NUMBER: 09-70-19

SERVICE INFORMATION BULLETIN

APPLICABILITY: 2019-20MY Legacy and Outback

SUBJECT: CVT Fluid Cooler Hoses and Clamps- Design Change

PART INFORMATION:

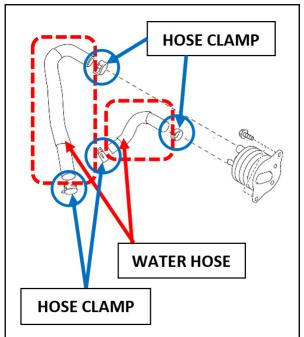
This Service Information Bulletin outlines design changes made to the coolant hoses for the CVT fluid cooler and the spring-type clamps used to secure them.

- The new coolant hoses appear the same as the originals except for the outer diameter which is 1mm smaller (the inner diameter remains unchanged).
- The new clamps are now black and silver (instead of all silver) as shown in the illustration. They also have a 2.1mm smaller inside diameter to work with the new hoses.

VERY IMPORTANT: There is NO interchangeability between the old and new -style parts. NEVER use an old -style clamp on a new -style hose and / or vice-versa.
